Project	IEEE 802.16 Broadband Wireless Access Working Group < <a href="http://ieee802.org/16">http://ieee802.org/16</a> >	
Title	Improved CTC Performance	
Date Submitted	2005-03-09	
Source(s)	T. Keith Blankenship Yufei Blankenship Brian Classon Motorola	keith.blankenship@motorola.com yufei.blankenship@motorola.com brian.classon@motorola.com
	Alek Purkovic Nortel Networks	apurkovi@nortelnetworks.com
	John Benko Marie-Helene Hamon France Telecom Research & Development	John.Benko@francetelecom.com mhelene.hamon@francetelecom.com
Re:	IEEE P802.16e/D6, sponsor ballot	
Abstract	This contribution demonstrates that the convolutional turbo code (CTC) interleavers for block sizes 120 bytes and above have performance deficiencies. By selecting different interleaver parameters for these block sizes, the deficiencies can be corrected. The performance improvement in AWGN at $10^{-4}$ FER with the new parameters is at least 0.5 dB and in some cases up to 1.3 dB.

Purpose	To provide improved CTC channel coding interleaver parameters when supporting H-ARQ.	
Notice	This document has been prepared to assist IEEE 802.16. It is offered as a basis for discussion and is not binding on the contributing in

Figure 1. FER performance for currently specified CTC interleavers.

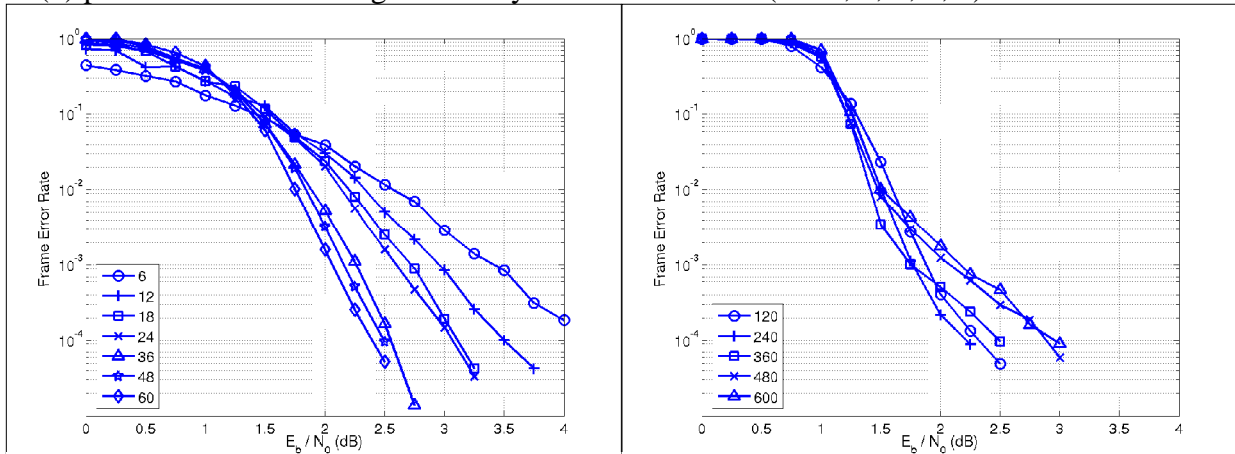
The performance of the  $6n$ -byte block sizes displays the expected turbo code behavior of improving performance with increasing block size. Furthermore, no error floor is discernable down to a FER of  $10^{-4}$ . However, the performance of the  $120n$ -byte block sizes displays the opposite. Here, the performance degrades with increasing block size (above 240-byte) and a distinct error floor is present.

Figure 2. Performance with new CTC interleaver parameters.

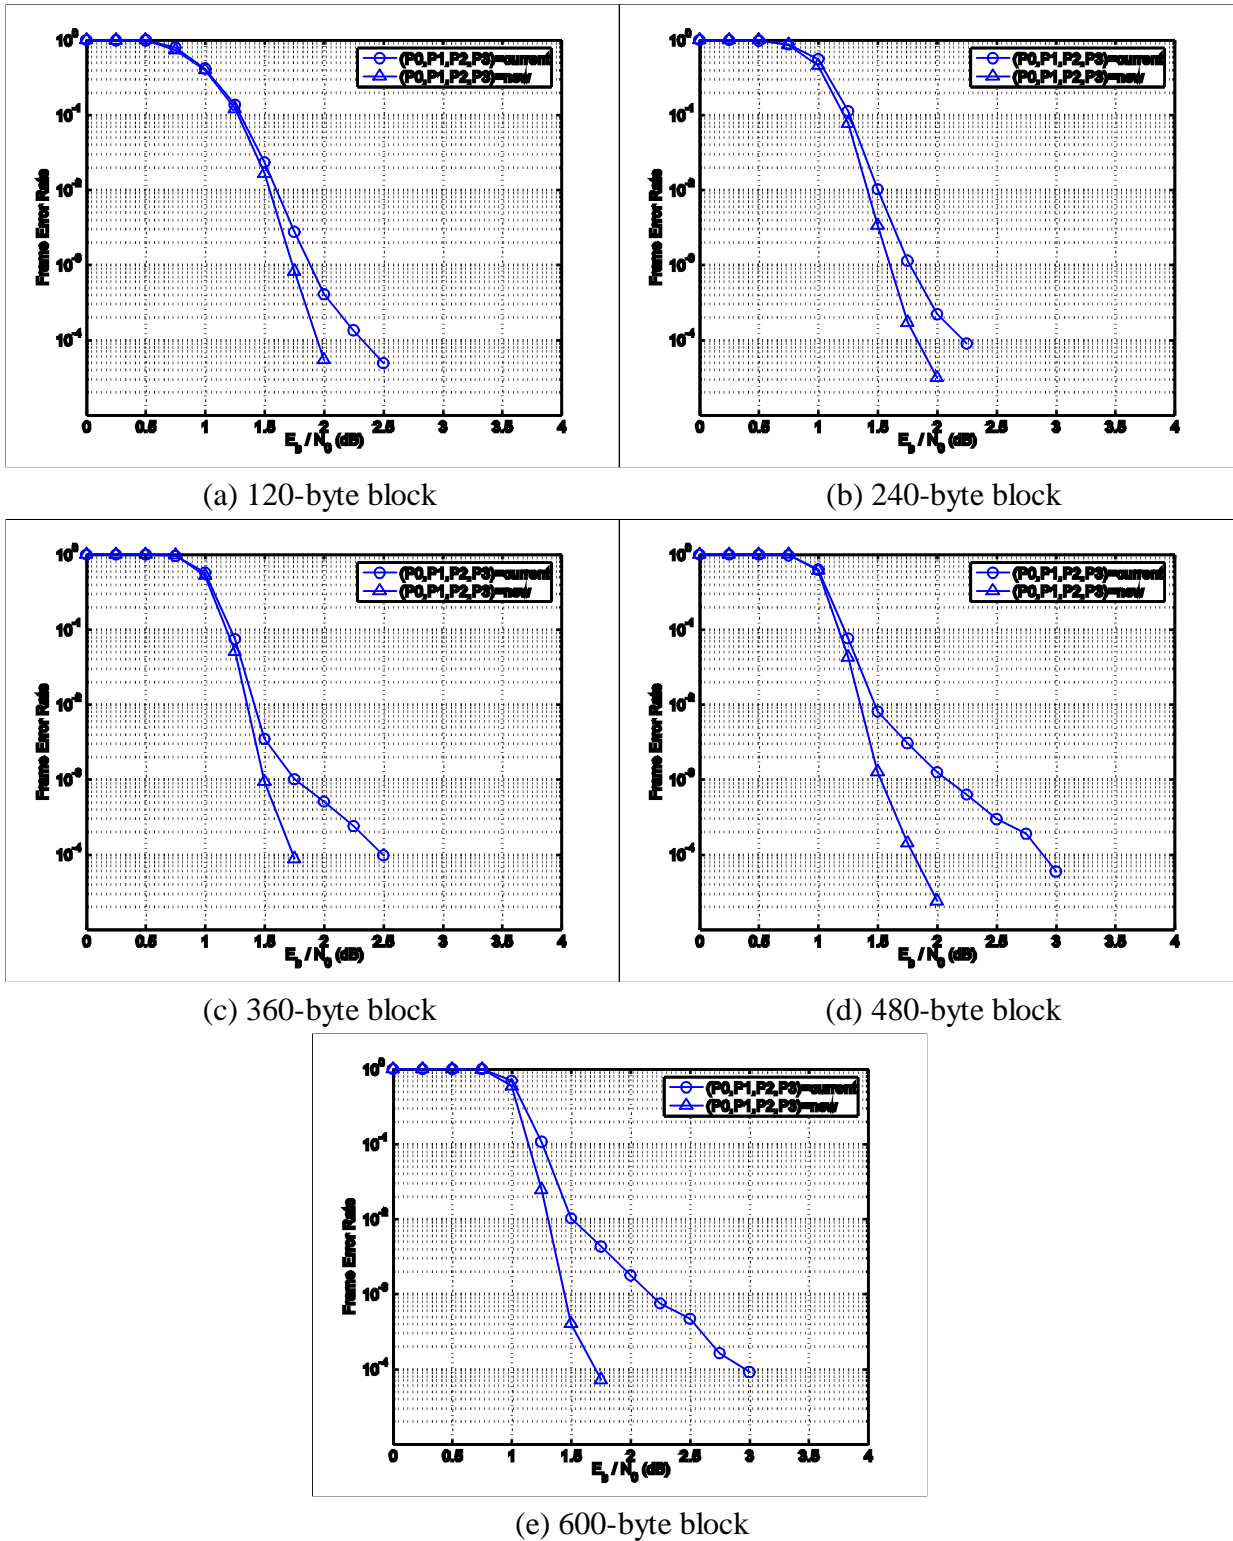
A new set of CTC interleaver parameters was designed to correct the performance deficiencies of the  $120n$ -byte block sizes. The new parameters were selected according to guidelines prescribed in [1]. The FER performance (rate-1/2, binary modulation, static AWGN channel, 7.5 decoding iterations, and “genie” circulation state knowledge) with the new parameters is plotted in Figure 2. The figure shows that the new parameters

correct the performance deficiencies of the current parameters. At  $FER = 10^{-4}$  the performance with the new parameters is at least 0.5 dB and in some cases up to 1.3 dB better than with the current parameters.

Figure 3. Cross simulation provided by Nortel on the existing and new CTC interleaver parameters.

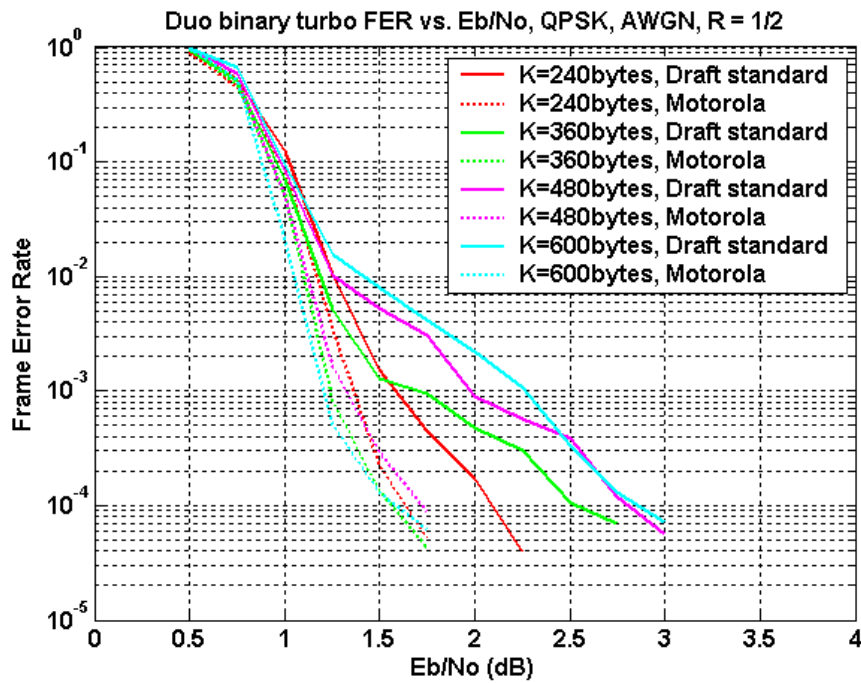
The proposed interleaver parameters have been independently tested by Nortel in comparison to the existing parameters. Their results in Figure 3 further support the significant improvement achieved by the proposed parameters.
